Town of Hilton Head Island Regular Design Review Board Meeting

Marriott Grande Ocean- View Corridor Pruning and Removals – Beach View

PROJECT NAME: _Marriott Grande Ocean

DRB#: DR120001

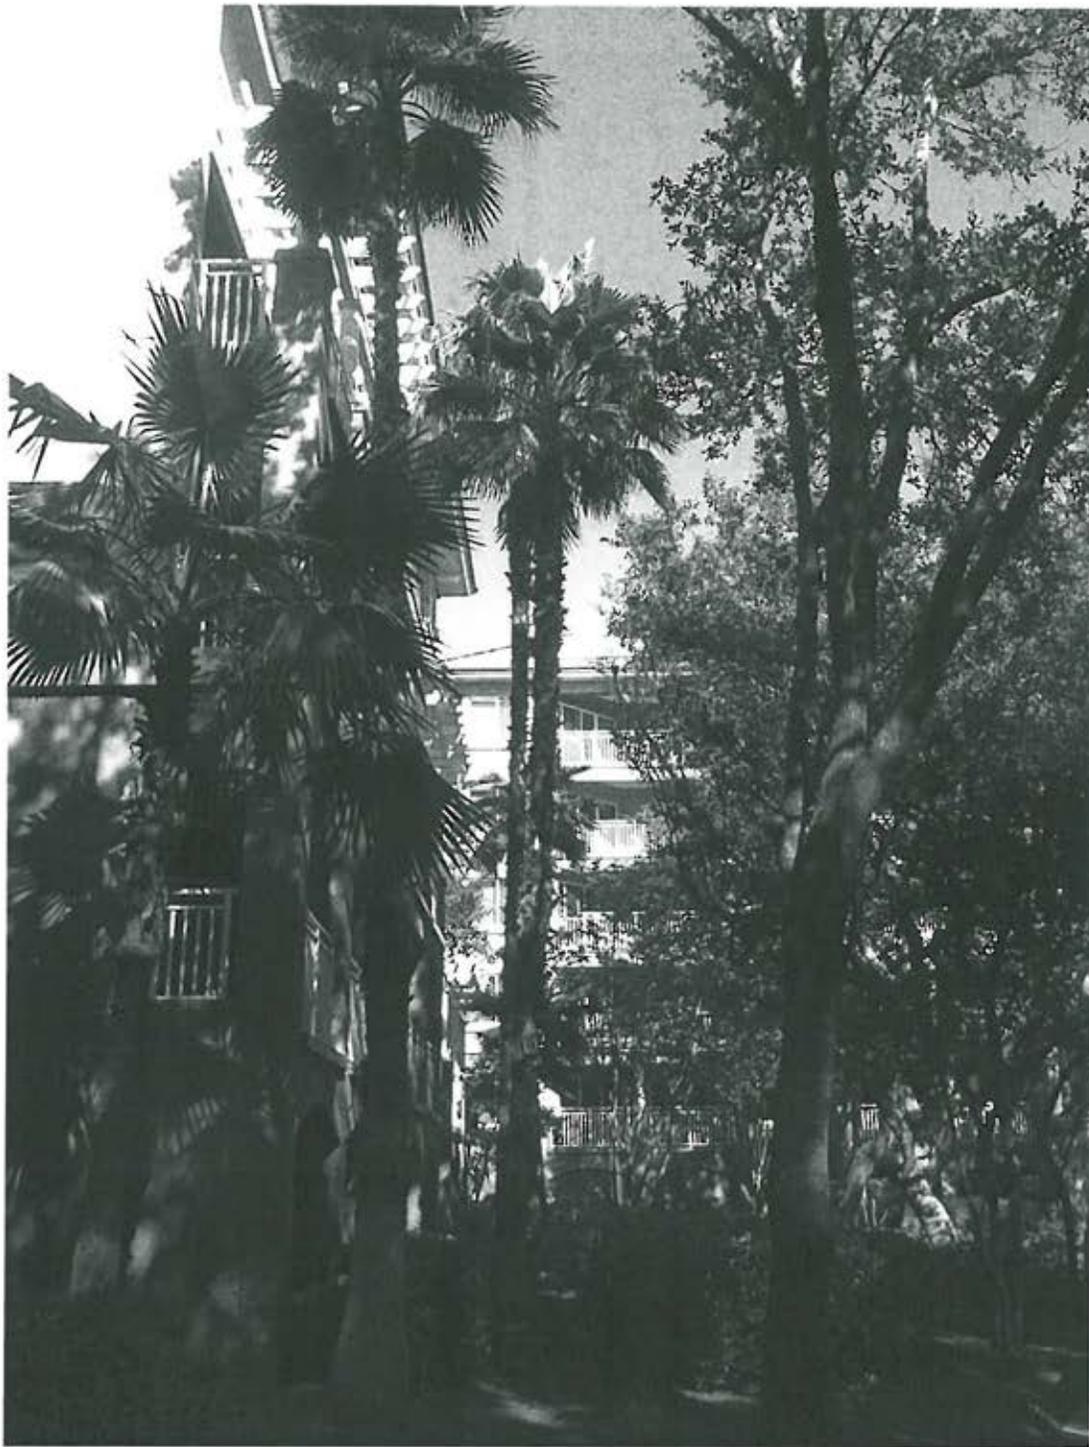
The *Washingtonia sp.* that is concentrated in the courtyards has developed in a shaded location dwarfed temporarily by large Live Oaks that were native to the site at the time of construction and the palms' planting. These palms were subsequently forced to grow at a more rapid pace in order to stretch for necessary sunlight to photosynthesize. This rapid growth caused a tapering of the trunk as they did not allow themselves to develop trunk girth equal to that put on during nursery/field development which reduces the structural integrity of the palm. They now extend over the Oak canopy which exposes them to more direct ocean breezes that create a large sway in the trunk of the tree. This coupled with the fact that the trees were planted less than four (4) feet away from the building, see Appendix 1, and have a growth habit of 10'-15' of spread these trees are now being pushed into the balconies and façade of the building posing a risk to structure and guests. *Washingtonia sp.* are also susceptible to root rots and fungal infections, such as, Ganoderma which can cause rapid decline or complete failure of the tree at the base. This is especially present when the palms are planted in areas of high moisture exposure, i.e. irrigation to surrounding plant material, and low levels of sunlight to dry soils out, the palms are squeezed between dense Live Oak canopies and six story buildings, thus allowing fungi to breed more readily.

Appendix 1: Washingtonia palms planted too close to structure and not allowed to have room to move in heavy winds

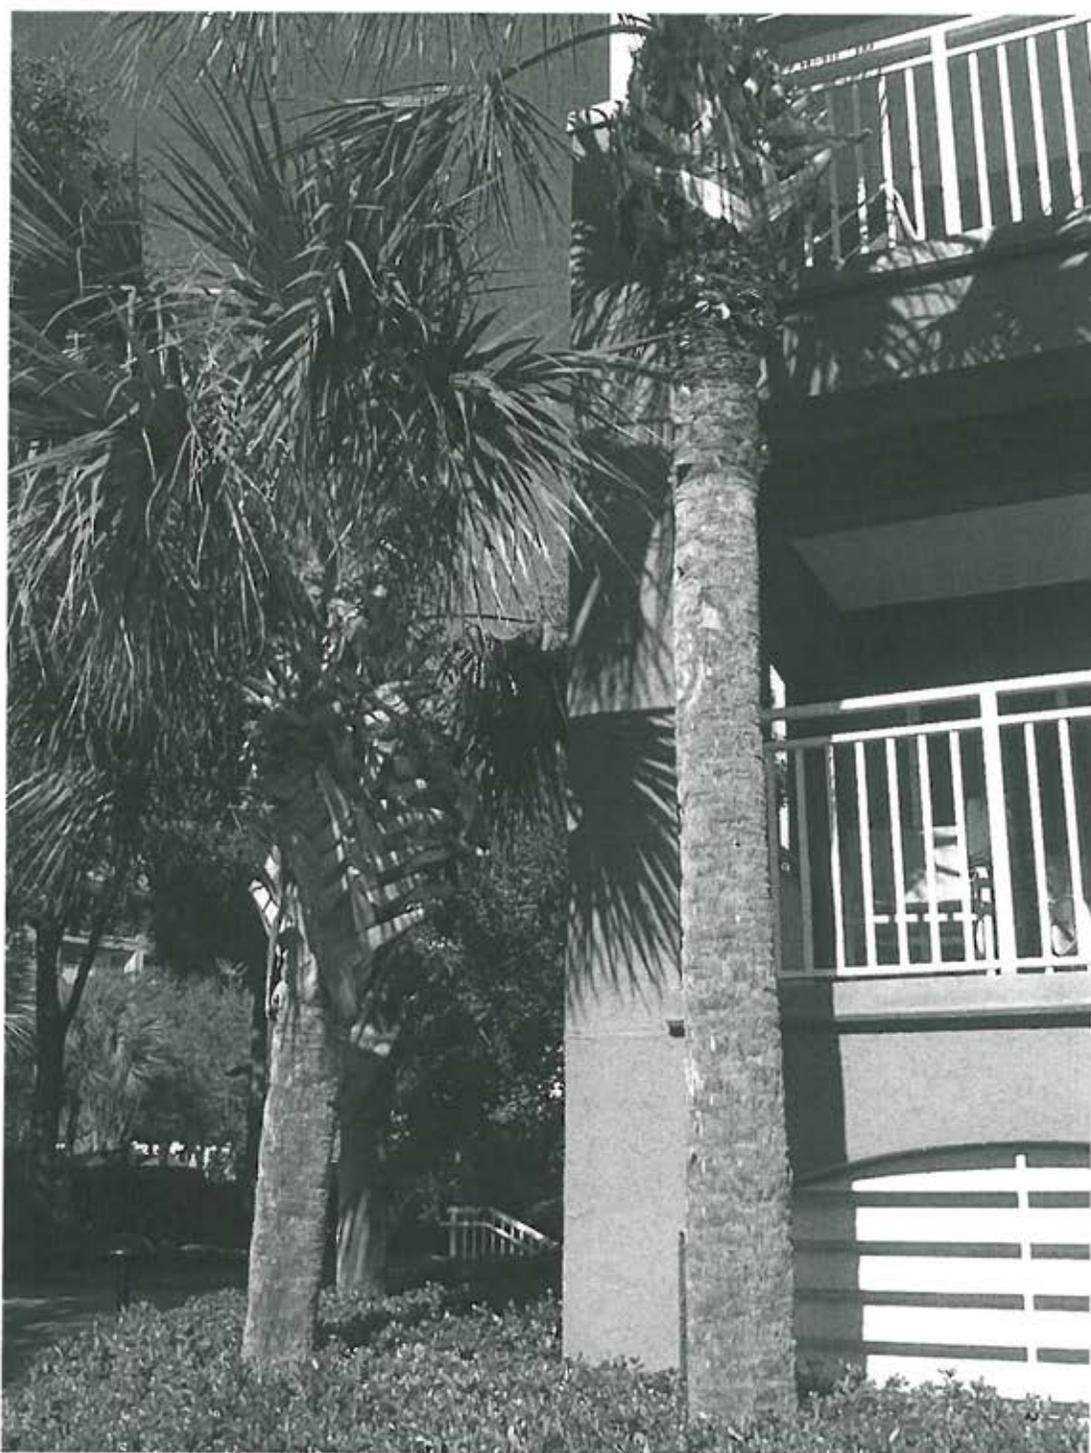
fronds along the side of the building being in constant contact with the structure. This creates a pathway for insect activity and rodents onto guest balconies and rooms, see Appendix 2,3. In addition, their direct exposure to ocean winds causes banging and slapping of the fronds against the structure, as well as, taller palm trunks hitting awnings. The location of the palms and need to constantly prune them will manifest itself into a much larger problem in the future. The removal of excess fronds from the upper portions of the palm head has created a "pencil point" effect where the trunk diameter begins to narrow as years go by and the trunk does not have the time and energy necessary to develop fully, see Appendix 4. Continual growth like this will create a very weak and narrowed trunk that does not have the structural integrity of the original stem. This coupled with the constant exposure to the ocean winds can cause them to snap off putting the building and guests at risk should it fall onto the balconies or the sidewalk below that many of these palms lie along.

Appendix 4: Examples of trunk tapering from over pruned palms

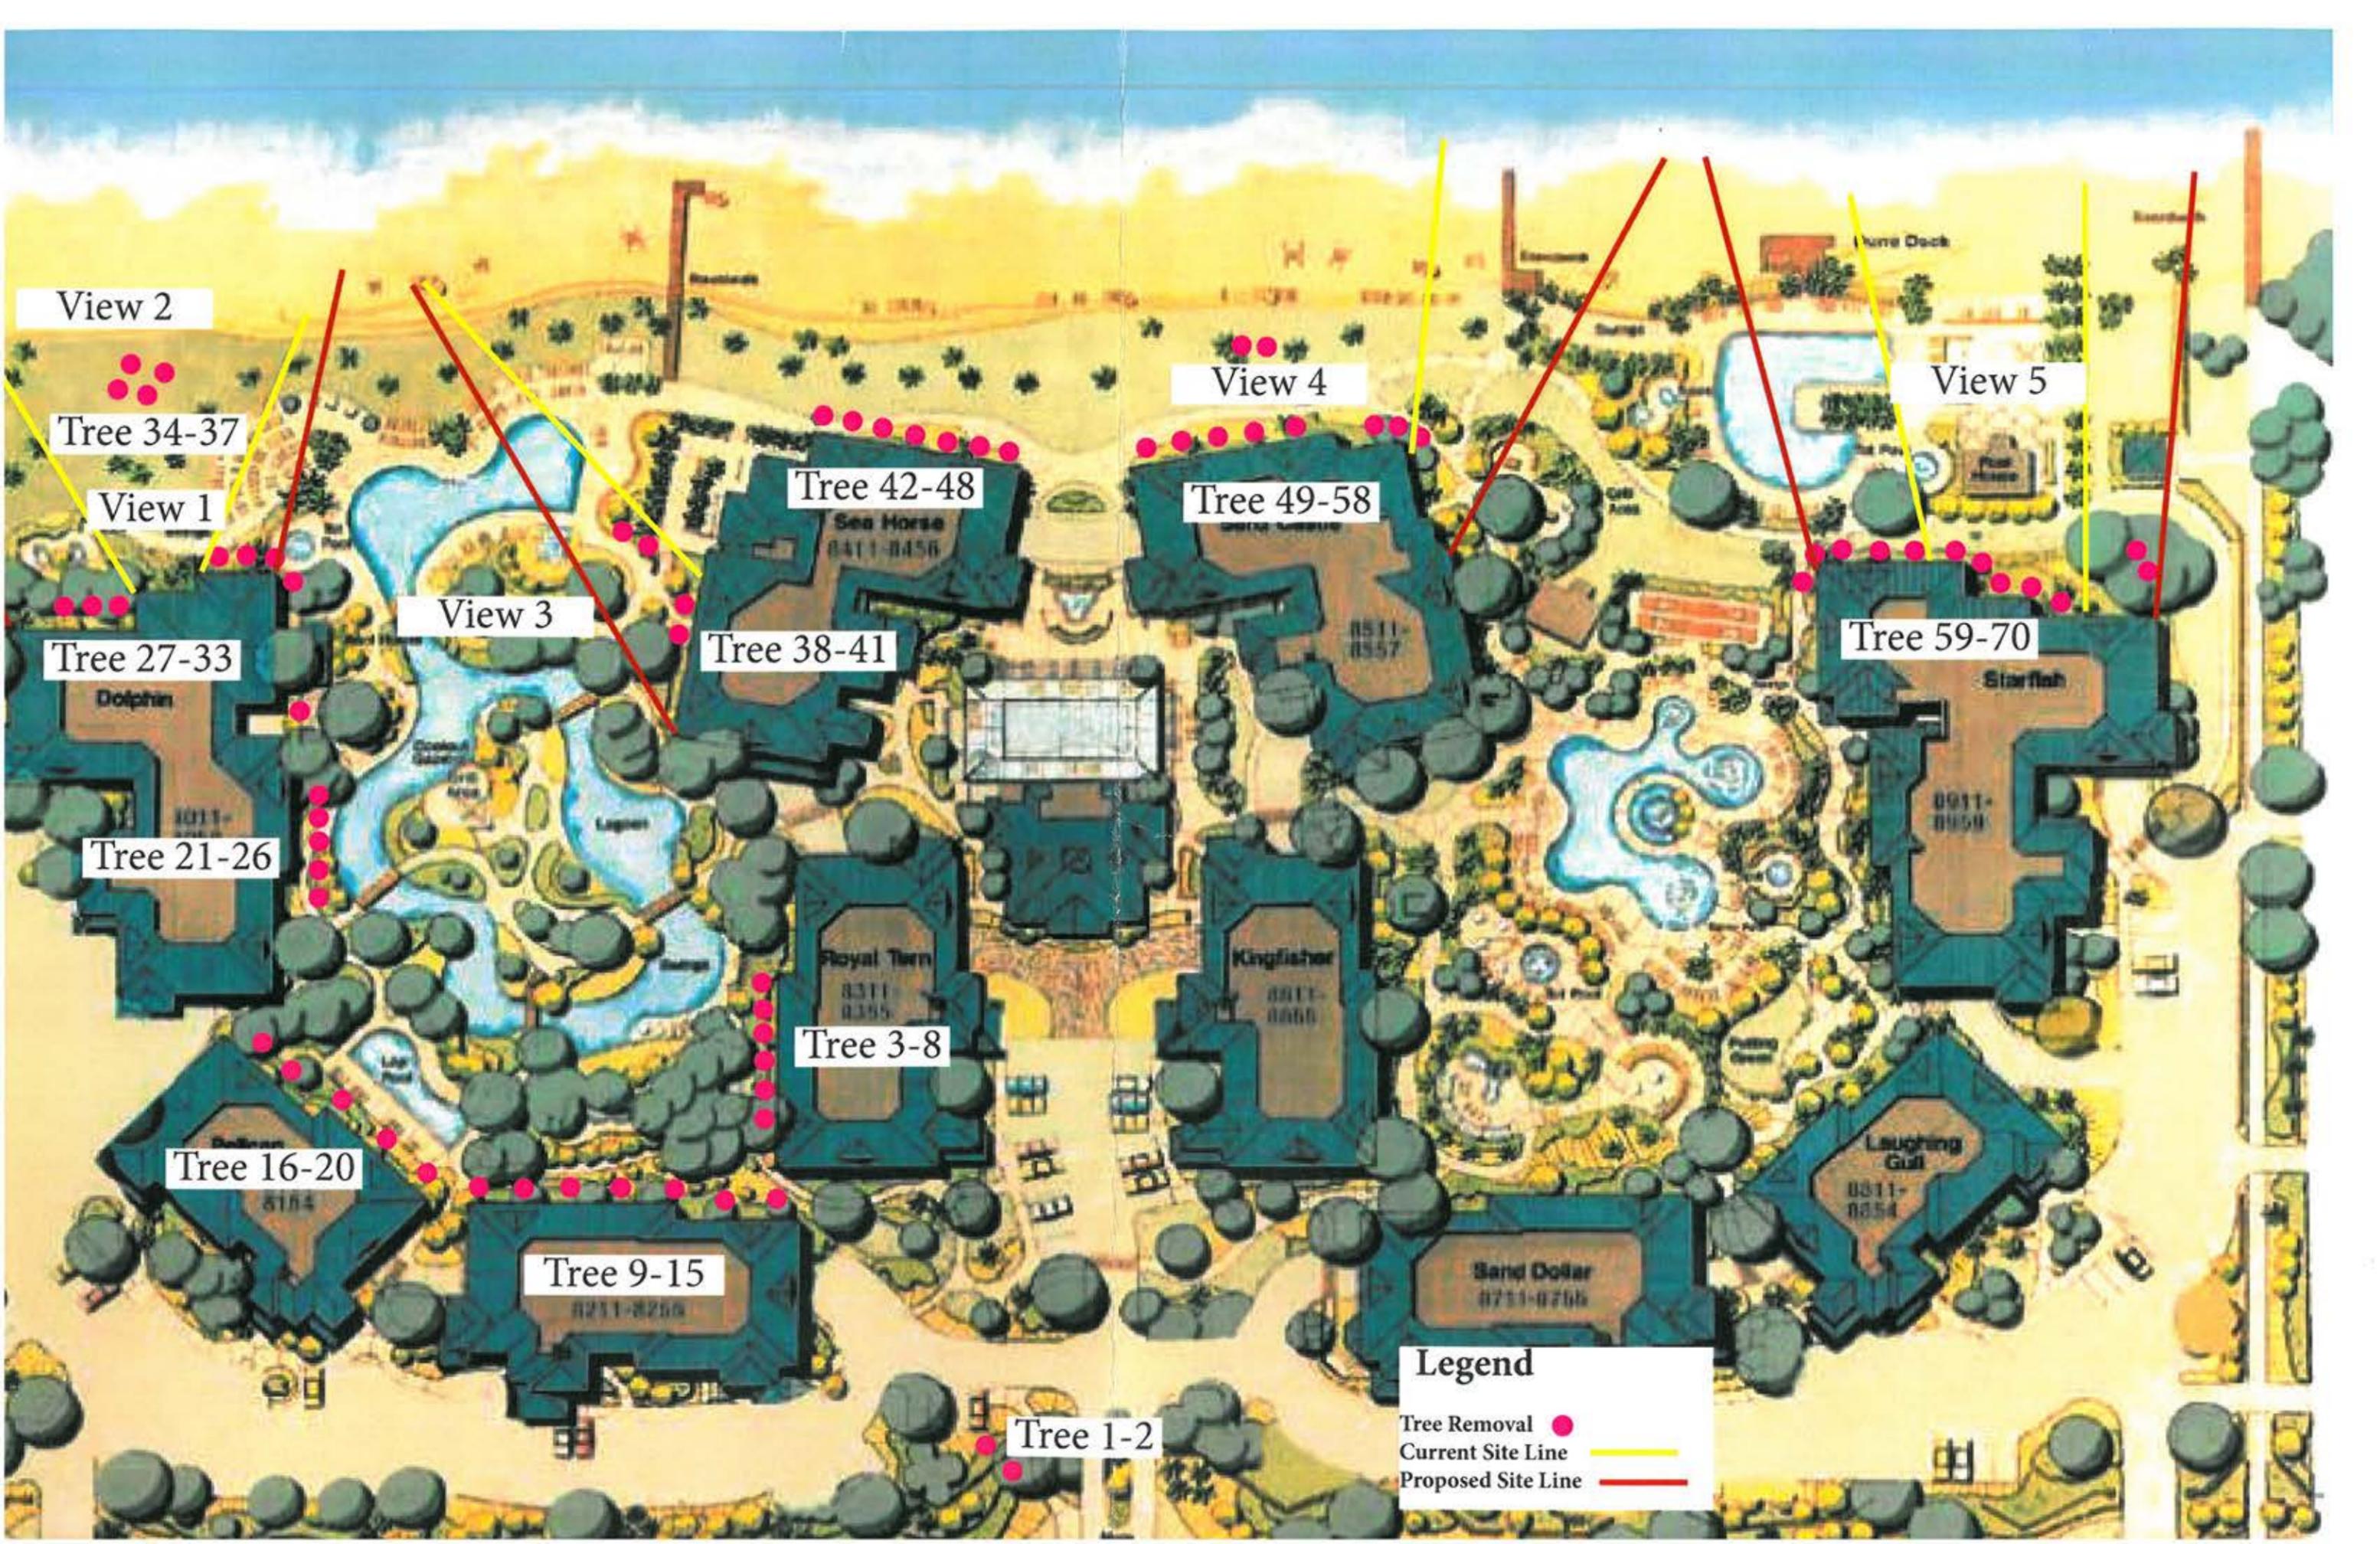
Appendix 2: Sabal palms planted too close to structure and growing into guest balconies

Appendix 3: Sabal palms to close to balcony having to be pruned severely on one side

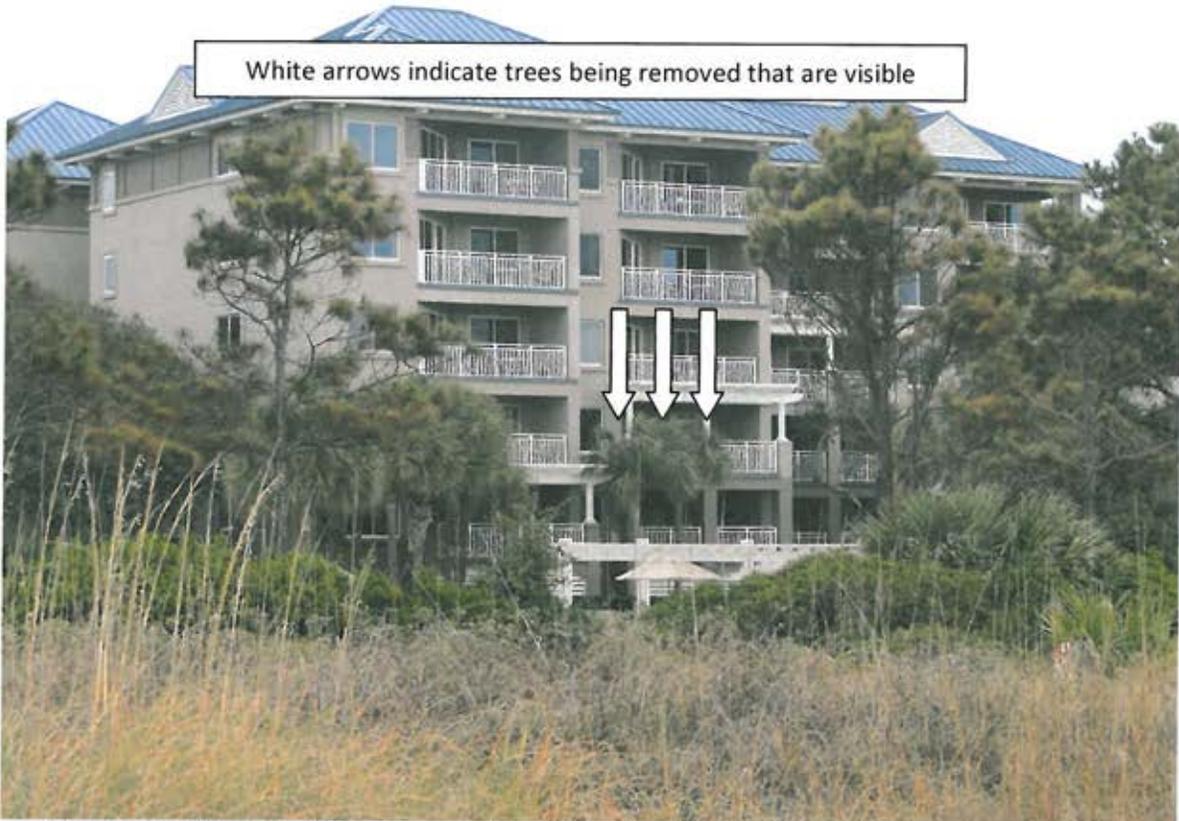
Northern Property Line- No requested trees against Building 80 are visible through dune growth and Pines

Middle of Building 80- View Corridor Pruning #2 where stand of Pines would have smaller trees removed
